A585 Windy Harbour to Skippool Improvement Scheme

TR010035

7.11 Environmental Statement Changes and Corrections Document

Version	Date	Status of Version
Rev 0	May 2019	Deadline 2 Submission
Rev 1	July 2019	Deadline 4 Submission

VIEWPOINT 9 PHOTOMONTAGE: YEAR 1

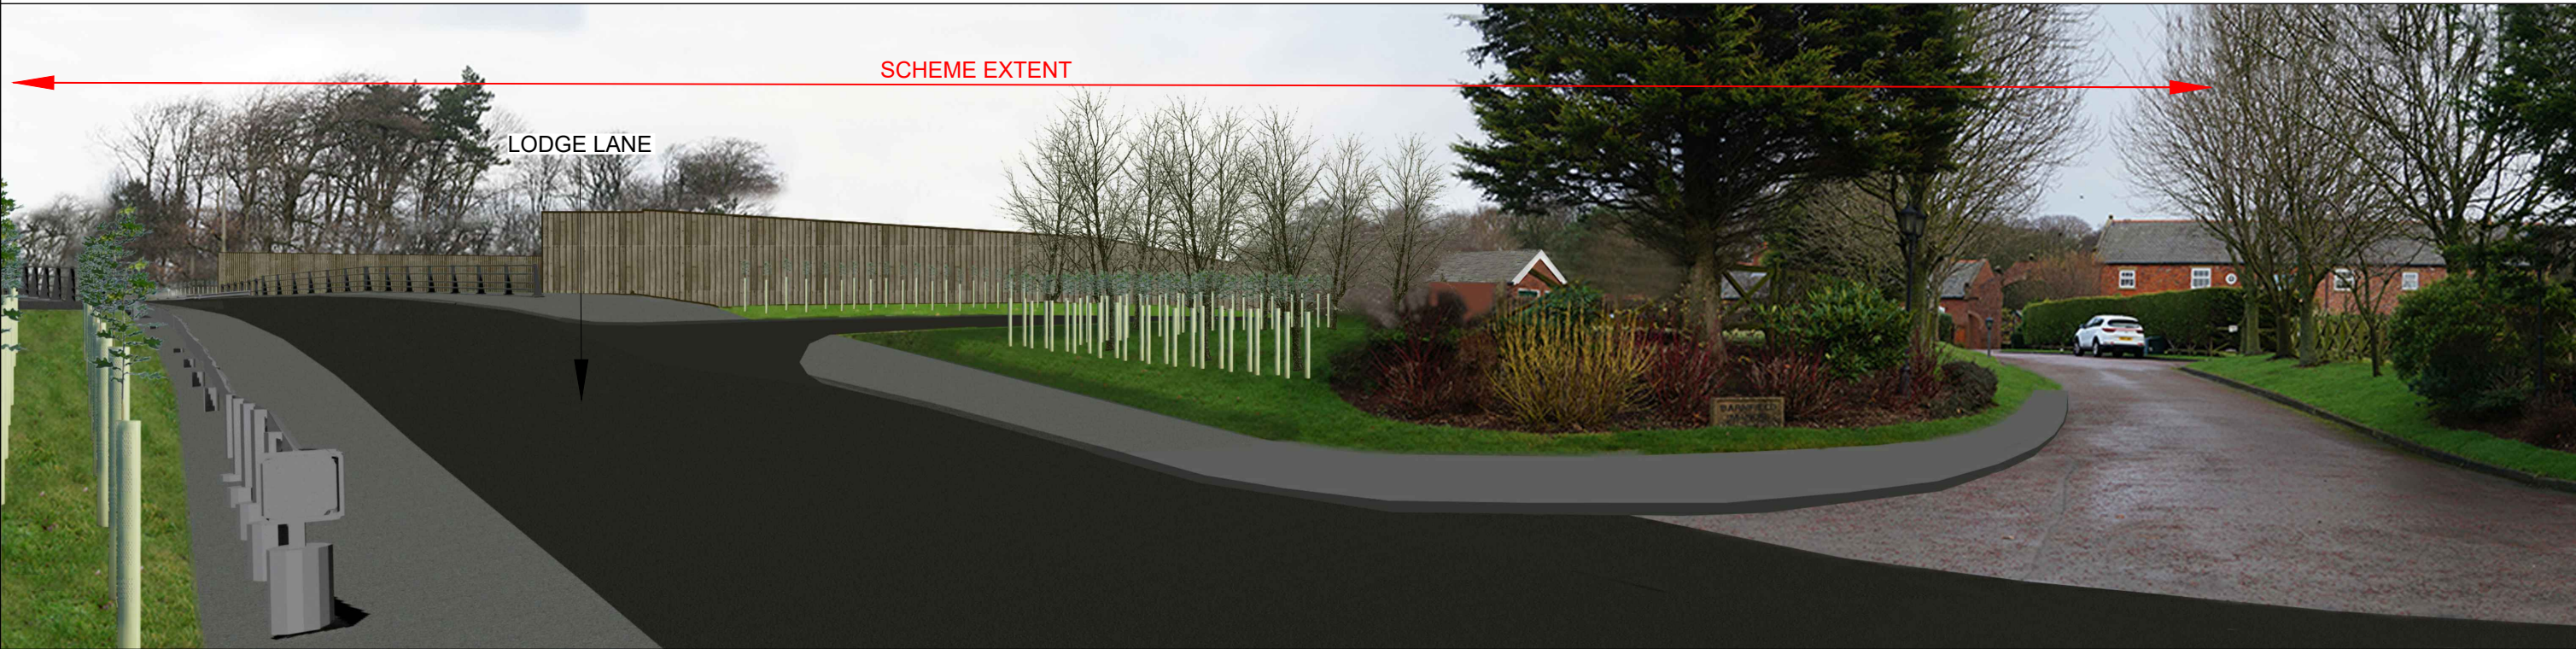
Document Reference Number	Document Name	Amendment Required			Reason									
6.9	ES Chapter 9: Landscape	Update to Figure 9.10, Photomontage at viewpoint location 2, view from residential properties on Breck Road provided within Appendix C.			As a result of updates to the Flood Risk Assessment associated with the dwarf wall.									
6.9	ES Chapter 9: Landscape	Update to Figure 9.10, Photomontage at viewpoint location 10, view from the B5260 Lodge Lane provided within Appendix C.			Updated to show the 3m high acoustic barrier to the north of the cutting.									
6.9	ES Chapter 9: Landscape	Update to Figure 9.10, Photomontage at viewpoint location 9, view from the A585 Garstang New Road provided within Appendix C.			Updated to show the additional linear planting adjacent to Grange Footbridge, as a result of request from Fylde Borough Council (document reference TR010035/APP/7.9).									
6.9	ES Chapter 9: Landscape	Update to Table 9-16

Project	A585 WINDY HARBOUR TO SKIPPOOL IMPROVEMENT SCHEME		
Drawing Title	ENVIRONMENTAL STATEMENT REGULATION 5(2)(a) NOISE AND VIBRATION: NOISE MONITORING LOCATIONS WITHIN STUDY AREA

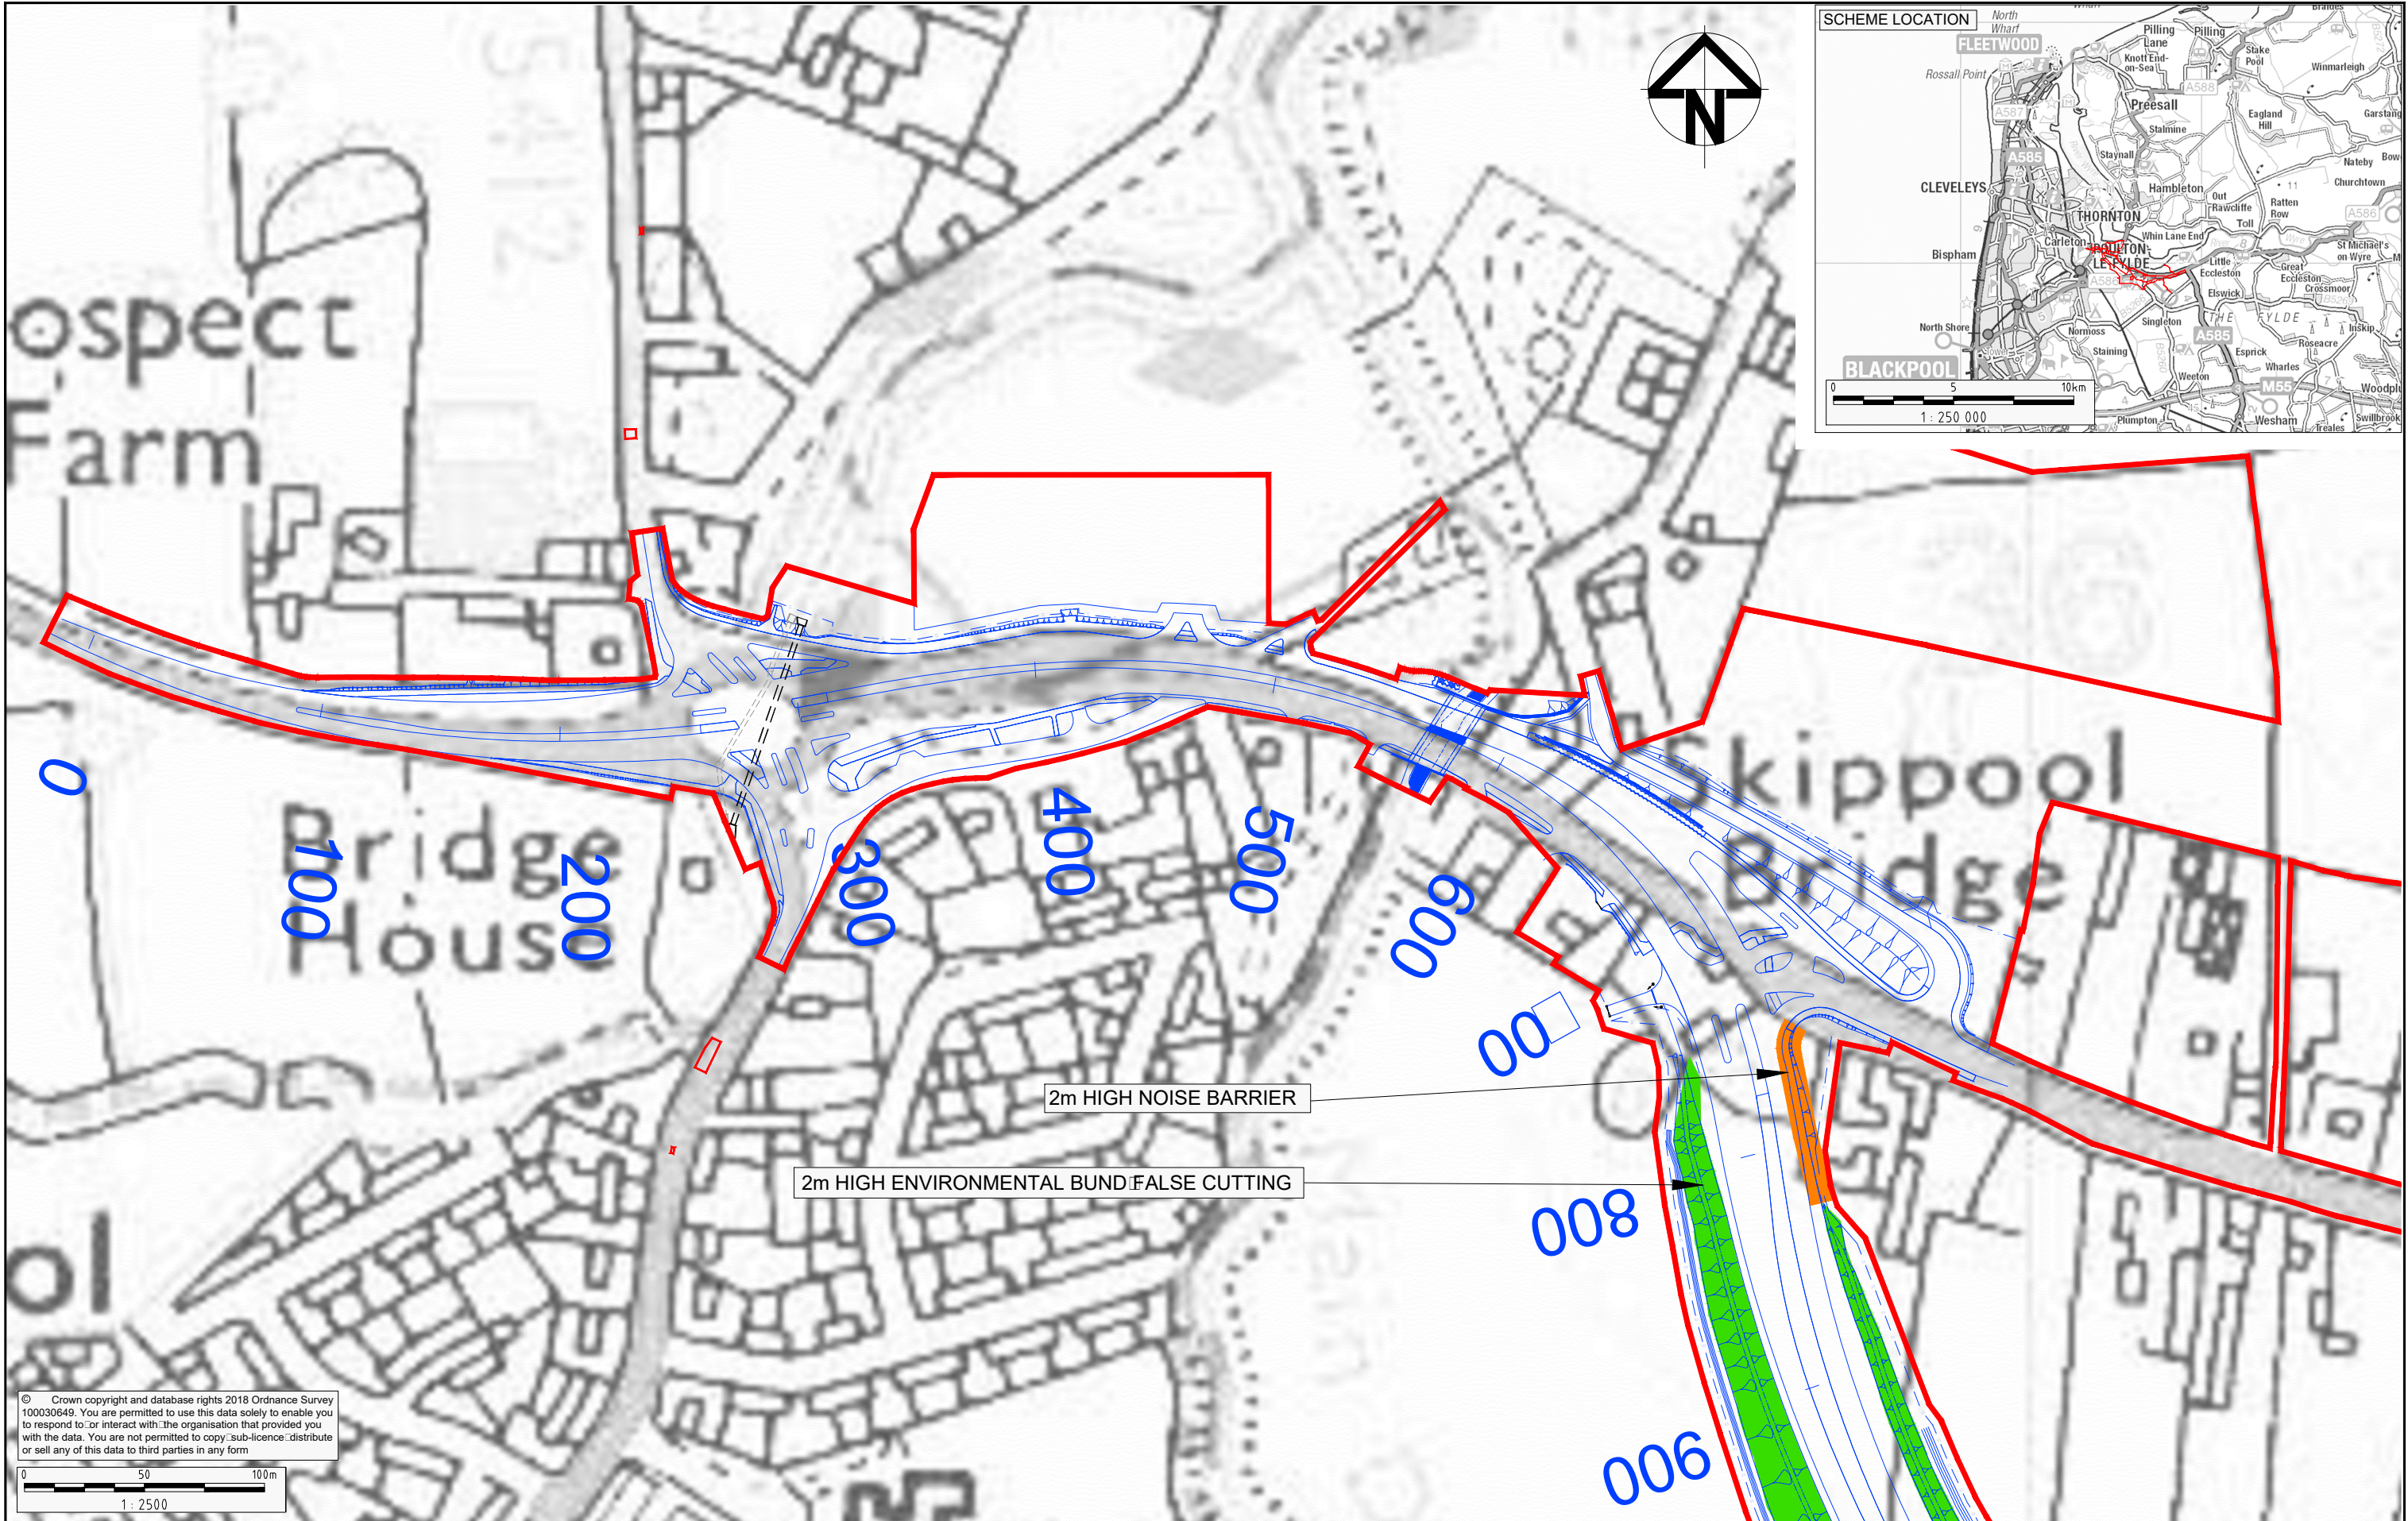
6.11	ES Chapter 11: Noise and Vibration	Update to Figure 11.1: Noise and Vibration – Noise Monitoring within the Study Area presented at Appendix D to show the locations of the eight attended noise surveys.	Requested by the Inspector within the first round of written questions (document reference

Drawing Title ENVIRONMENTAL STATEMENT REGULATION 5(2)(a) NOISE AND VIBRATION: NOISE MITIGATION SHEET 1 OF 6

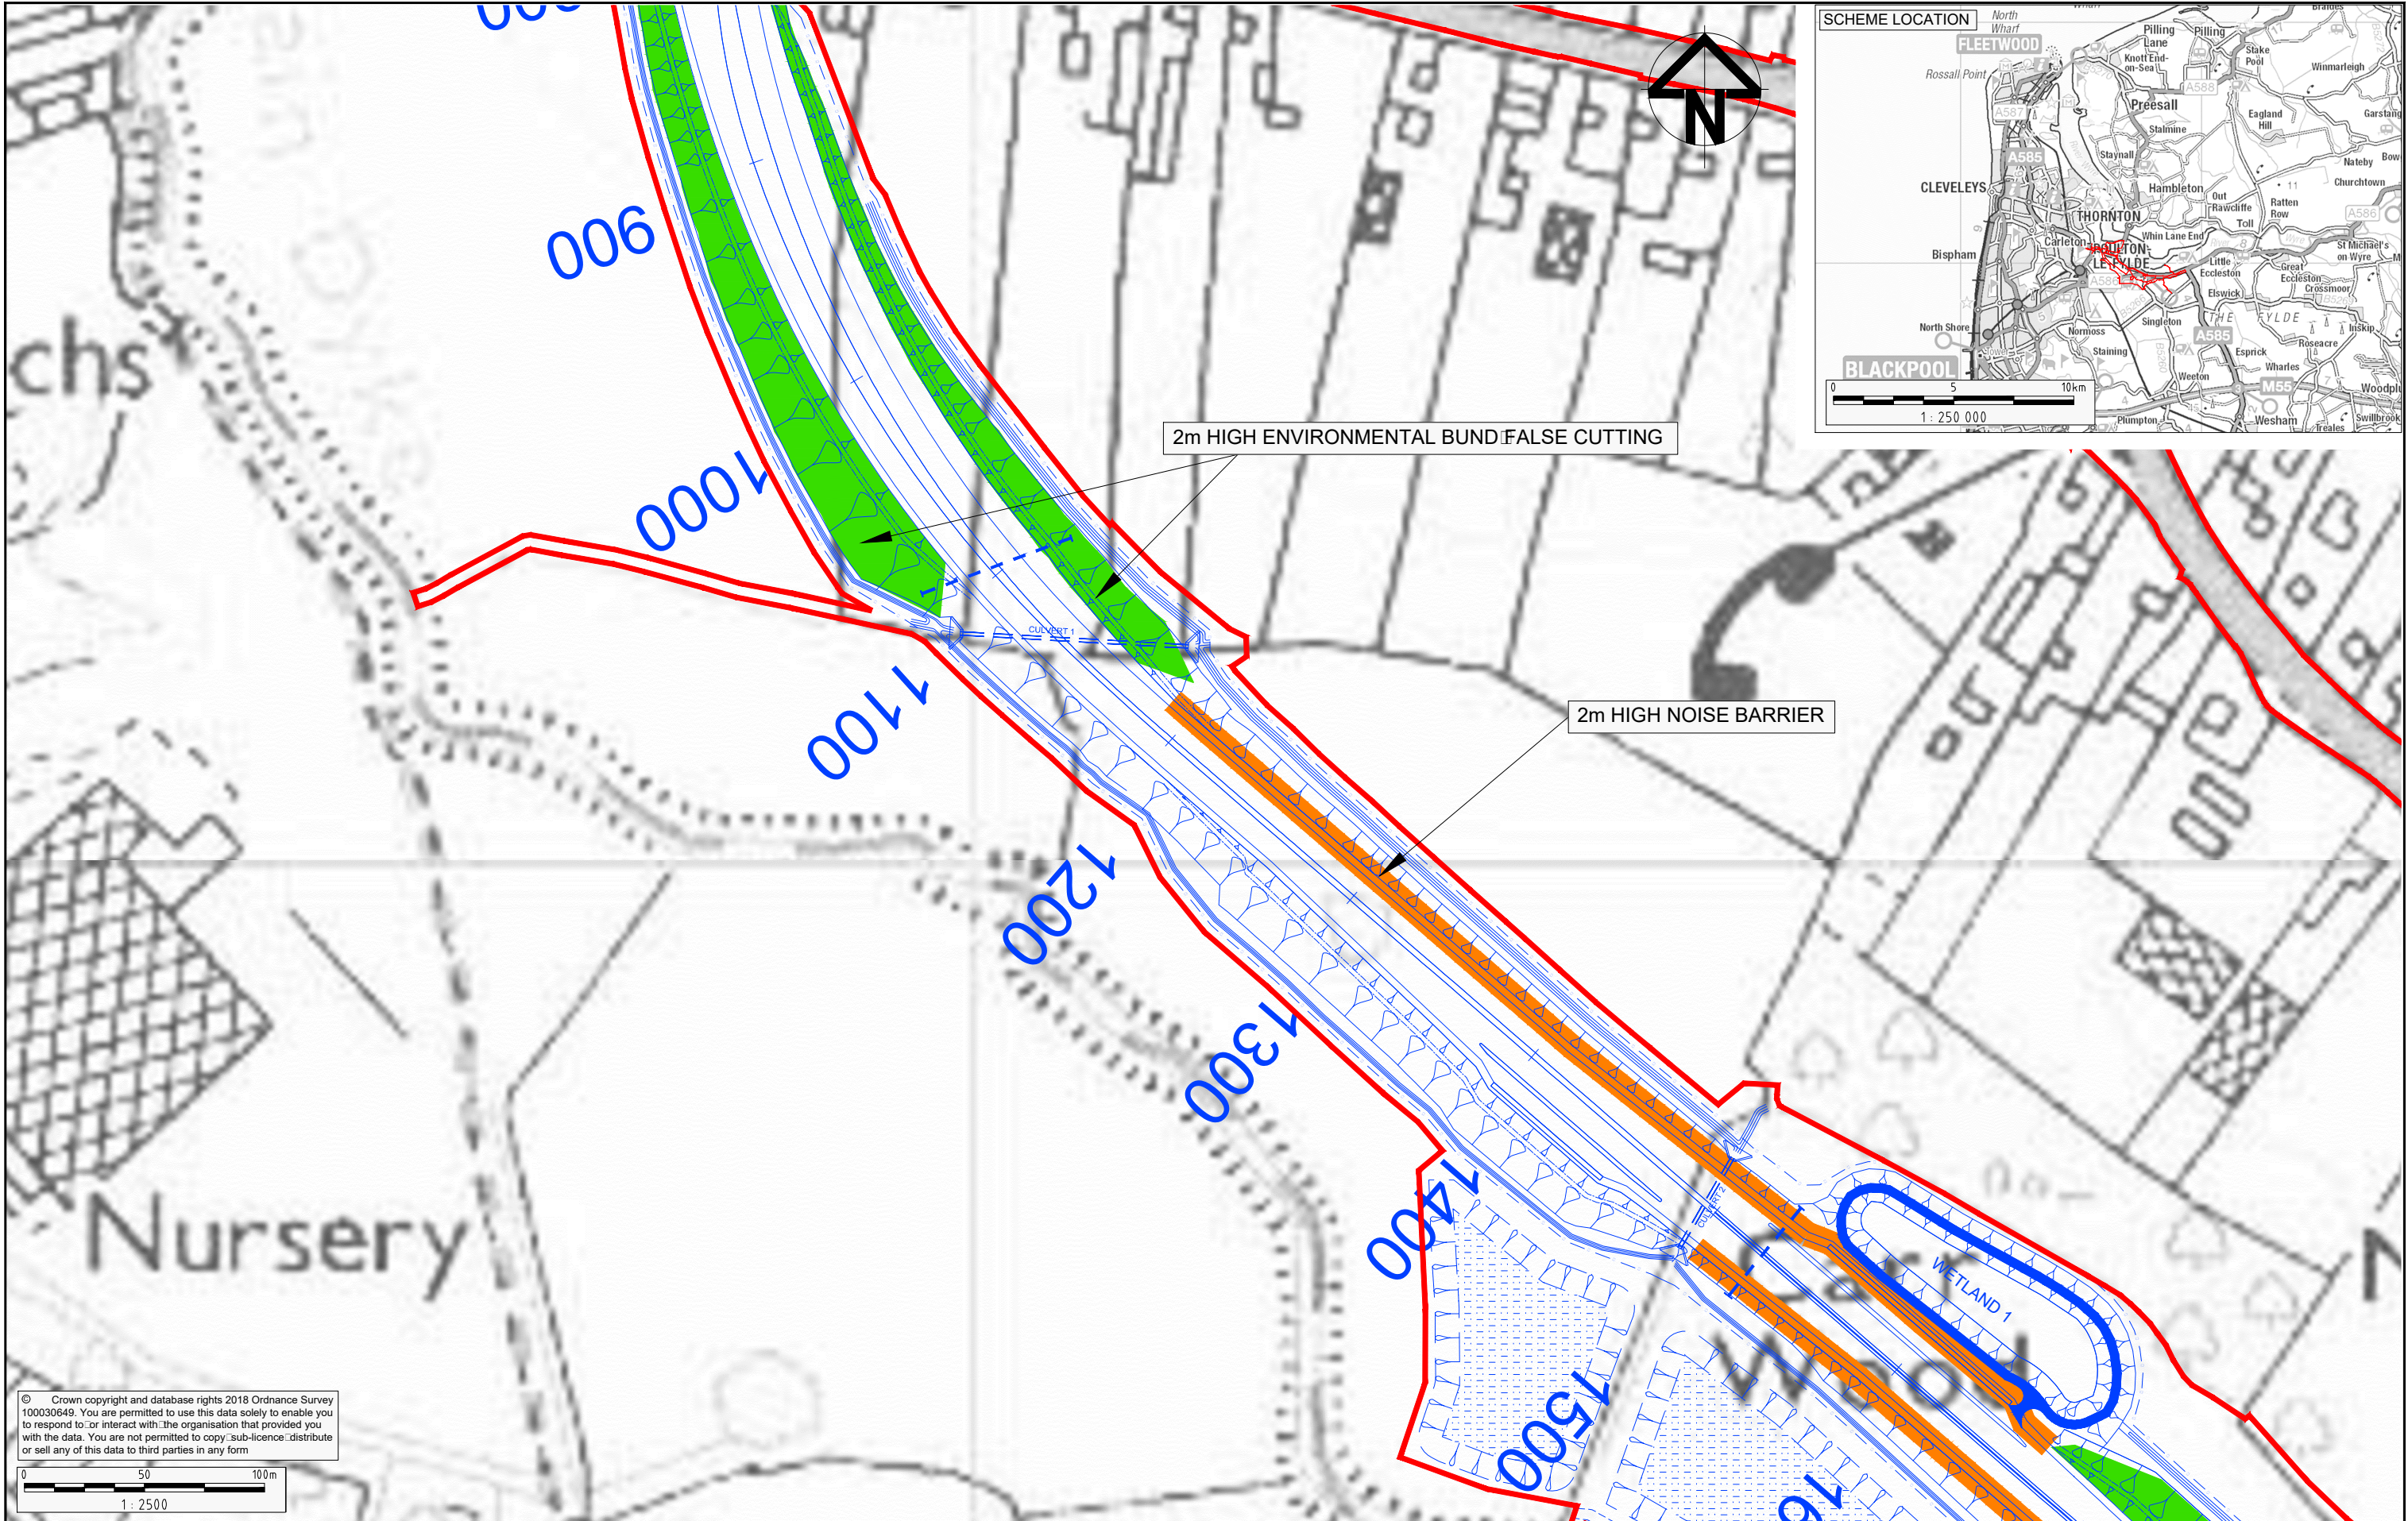
Document Reference Number	Document Name	Amendment Required	Reason
			TR010035/APP/7.10).
6.11	ES Chapter 11: Noise and Vibration	Update to Figure 11.4: Noise and Vibration – Noise Mitigation within the Study Area presented at Appendix D to show heights and locations of earth mounds and acoustic fencing at a larger scale.	Requested by the Inspector within the first round of written questions (document reference TR010035/APP/7.10).
